Access Compliance Report

Public Rights-of-Way

(Curb Ramps)

Intersection ID: 10903	Main Street: TIPPERARY_PL	Cross Street: VINETTA_CT	Location:	W
ADA ID: 198421D3611A	Ramp Type: Para	Initial Pass/Fail: Fail	Overall Compliance: No	Severity Score: 1.25
Codes/Mitigation Info/Possible Solution		Field Measurements/Component Compliance

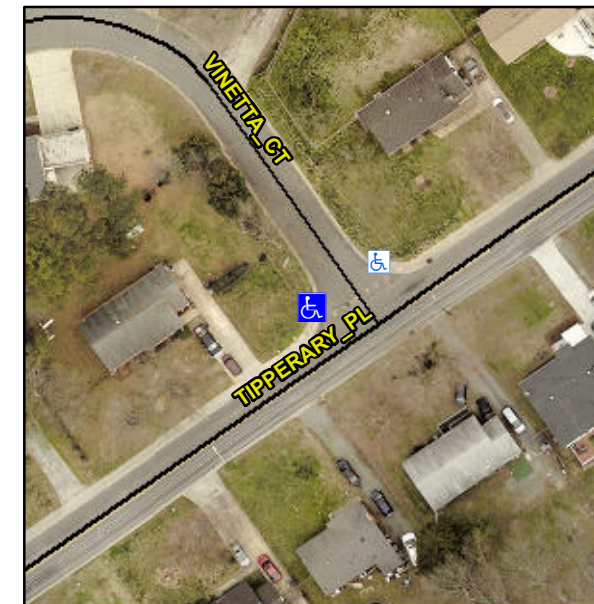
LT RP < 5%

R304.5.3

Remove & Replace Entire Ramp.
